Item 5.**Development Application: 108-112 Victoria Street, Beaconsfield - D/2021/1054****File No.:** D/2021/1054**Summary****Date of Submission:** 16 September 2021; with the latest set of amendments and additional information received on 14 April 2022.**Applicant/Owner:** 110 Victoria Street Pty Ltd**Architect:** Derek Raithby Architecture**Cost of Works:** \$1,075,000.00**Zoning:** The site is located in the R1 General Residential zone. The proposal is defined as attached dwellings and secondary dwellings and is permissible with consent.**Proposal Summary:** The subject application seeks consent for the demolition of existing structures, construction of three 3-storey attached dwellings, each with a part-two part-three storey laneway structure containing a garage and a studio and subdivision of the site into three lots.**Issues**

Figure 12: Approved side elevation of development at 134 Victoria Street (D/2021/730)

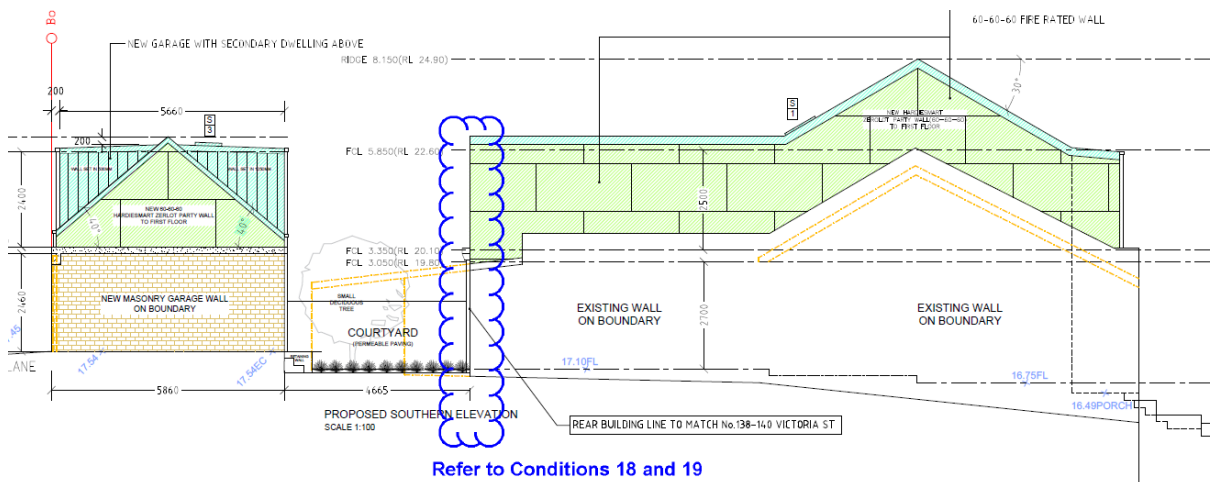
Provision	Compliance	Comment
		<p>The design of the laneway structures has been amended to have a maximum height of 5.4m when measured from Victoria Lane; a gabled roof form with 'dormer style' inserts to achieve compliant floor to ceiling height for an attic; and a parapet/gutter line height that is more typical of a single storey structure when viewed from Victoria Lane.</p> <p>A condition is recommended to require further amendments to the roof form to enable the window design to be modified to improve the internal amenity of the attic studio, reduce visual bulk and to minimise overshadowing to the living room glazing of the adjoining property to the south.</p> <p>Subject to this condition, the built form of the laneway structure will be consistent with the DCP's built form requirements for such laneway structures to present as single storey and to be consistent with the built form of the laneway structure at 134 Victoria Street as approved by D/2021/730 and as shown in Figure 12 above.</p>

Figure 17: Proposed Victoria Street elevation

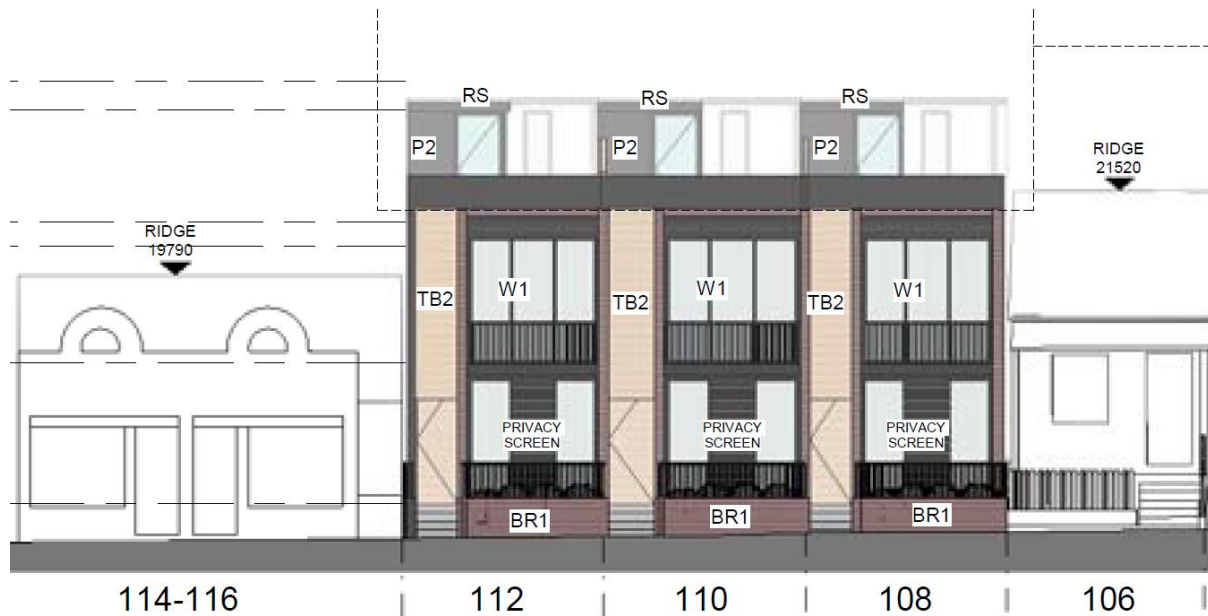
28. At a height of 8.52m, the proposed development complies with the LEP 9m maximum height of buildings development standard. However, the proposed design incorporates a third storey that is setback by 3.885m above the two-storey street frontage height to its the Victoria Street frontage.

Figure 24: Shadow diagrams

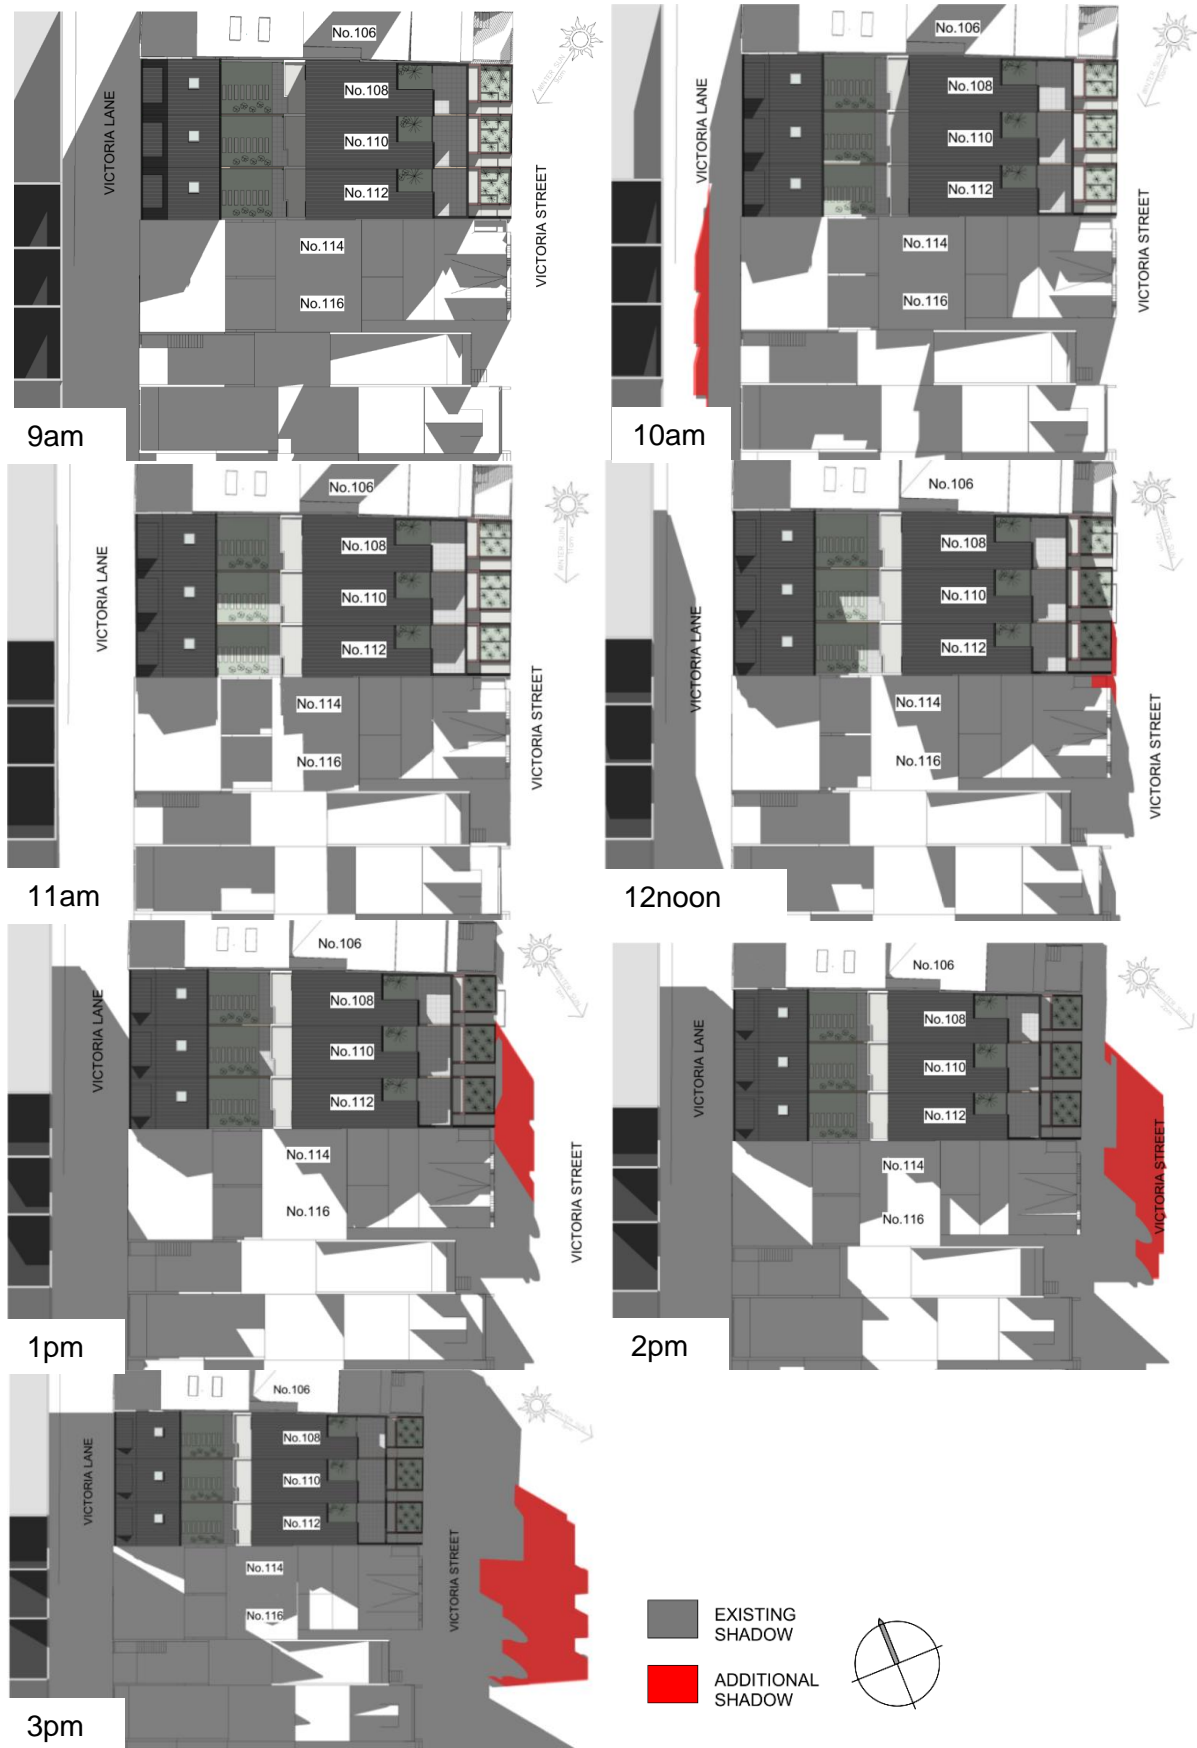
43. In relation to the subject site, the proposed development cannot achieve the minimum 2 hours of solar access to private open space and living room windows recommended by the DCP.

44. This is due to three factors. First, the narrowness of the lot means the new boundary fences will overshadow both the private open space and the ground floor living room glazing. Second, the northwest-southeast orientation of the site means the private open space and the ground floor living room glazing will be overshadowed by the dwelling in the morning and the laneway structure and boundary fences in the afternoon. Third, the topography of the site and surrounds results in greater overshadowing impacts by single storey developments to the north and along Victoria Lane, compared to overshadowing from these structures were there a flatter topography. Given the proposed development's non-compliance with the DCP's recommended solar access is primarily the result of contextual factors such as the size and shape of the lot, the orientation and topography of the site and the existing development context of its surrounds, the proposed non-compliance is acceptable.

45. As demonstrated in the shadow diagrams above, the proposed development will not result in any additional overshadowing to the private open space of adjoining properties to the south, which are currently overshadowed by the existing laneway structures and boundary fences.
